# DYNA-QUIK Model 650 DYNAMIC MUTUAL CONDUCTANCE TUBE & TRANSISTOR TESTER

## **B&K MODEL 650 SERVICE BULLETIN**

#### SERVICE BULLETIN 1-31-58

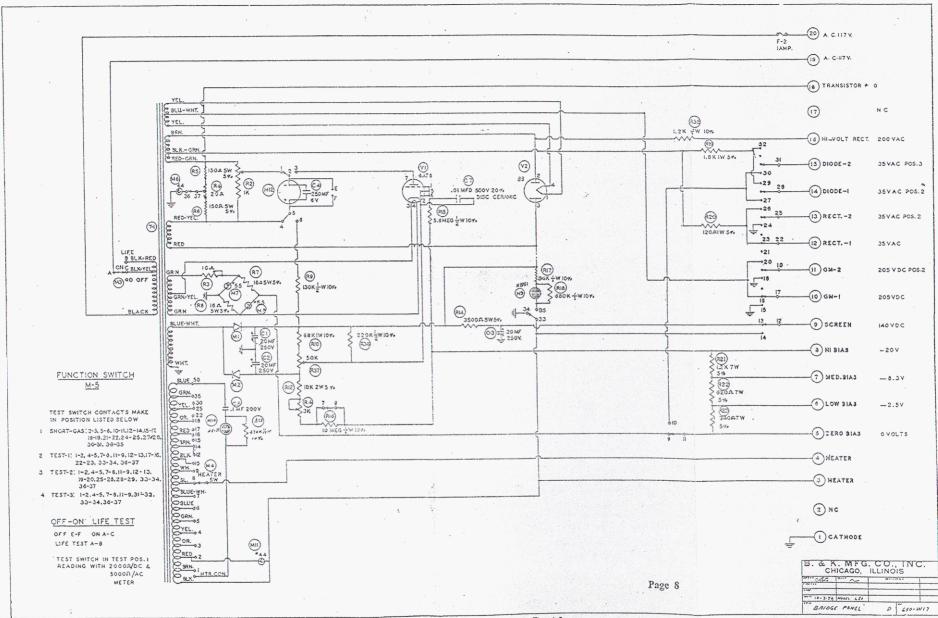
Change R-20 resistor this has been done in production at approximately serial # 4700 and above. Old R-20 is a 82 ohm 1 watt resistor.

The new R-20 must be a 120 ohm 1 watt 5% resistor ...

This is to prevent off scale deflection of the meter when testing low voltage rectifiers.

Schematic of Model 650 Test Panel.

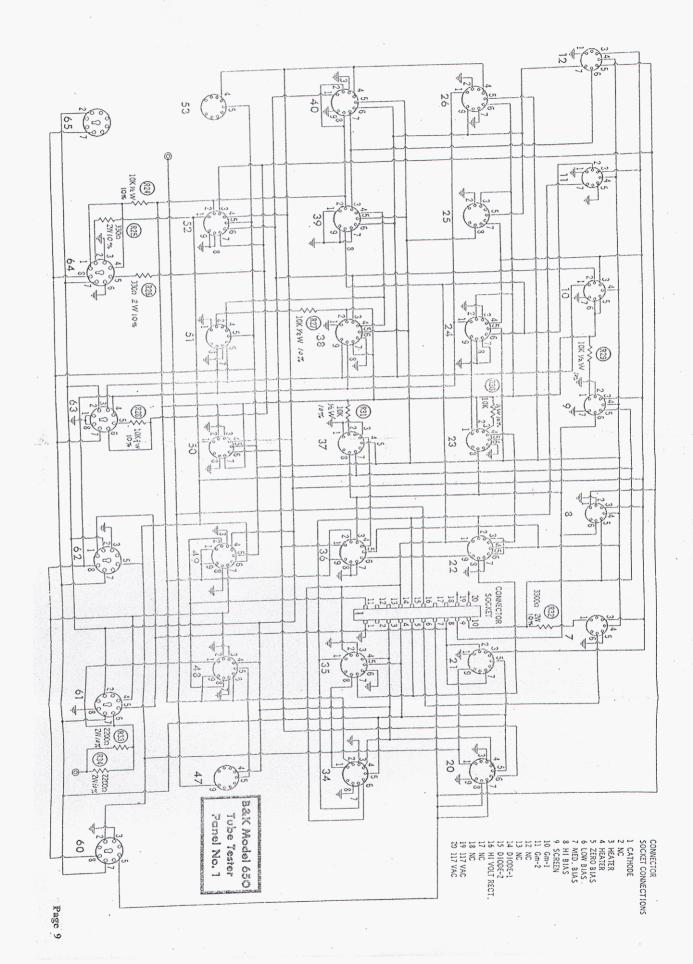
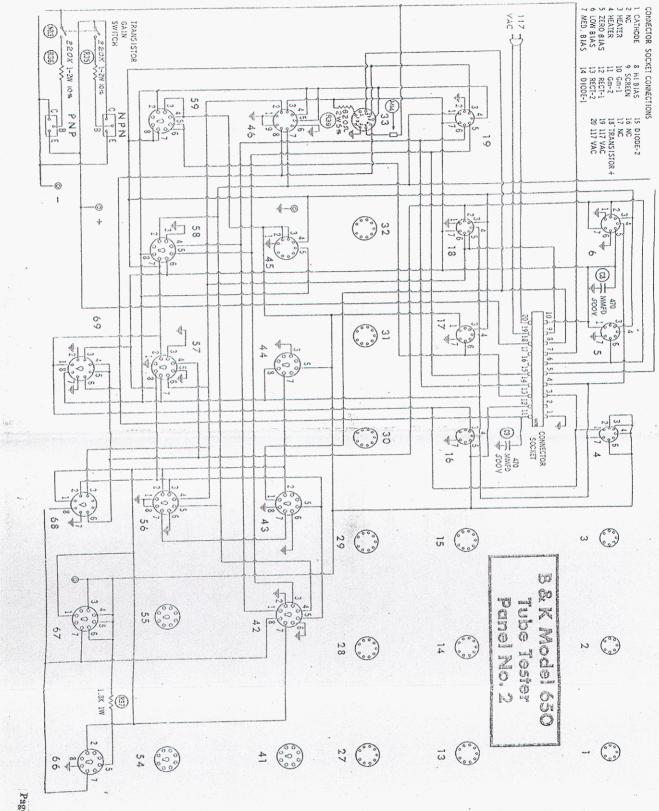
Add R-35 resistor this has been done in production at approximately serial # 4700 and up. Check to see if this change has bin made.

R-35 is a 1200 ohm 1/2 watt 10% carbon resistor in series with high

voltage terminal #16 on main panel.

Change **R-18** resistor this has been done in production at approximately serial # 5000 and above. Old **R-18** is a 270K ohm 1 watt resistor. The new **R-18** must be a 470K ohm 1 watt 5% resistor. This change increases the sensitivity of the shorts check.

Change R-10 and R-11 resistor this has been done in production at approximately serial # 6000 and above. Old R-10 is a 100K 1 waft resistor the new R-10 must be a 120K ohm 1 watt 5% resistor .Old R-11 is a 22K ohm 1/2 watt resistor, The new R-11 must be a 27K ohm 1/2 watt 5% resistor. This increases stability of the grid emission check.

WIRING OF 650 PANEL FOR USE OF 610
ADAPTOR PANEL

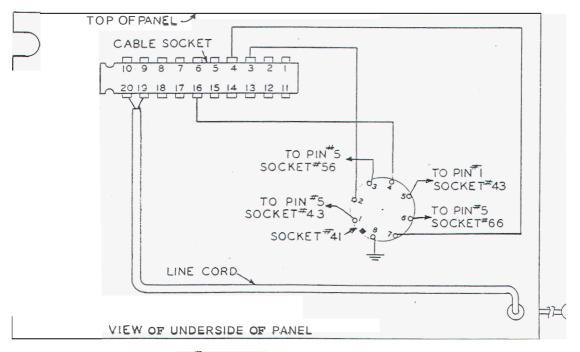
An octal socket (No. 41) on the Model 650 has to be wired in accordance with the following step by step instructions. Remove left hand socket panel by taking *out* wood screws.

```
1. Connect Pin 1 of Socket 41 to Pin 5 of Socket 43 using insulated wire.
```

```
2.
            ·· 2 ··
                          41 " " 3 of cable socket
                          41 " " 5of Socket 56
            " 3"
3.
                          41 " " 16 of cable socket
             ·· 4 ··
4.
                          41 " " 1 of Socket 43
               5 ...
5.
               6 "
                          41 " " 5of Socket 66
6.
            " 7"
                          41 " " 4of cable socket
7.
8.
            " 8 "
                          41 to ground lug of socket 41
```

Socket 41 should be wired as shown in Fig. 2.
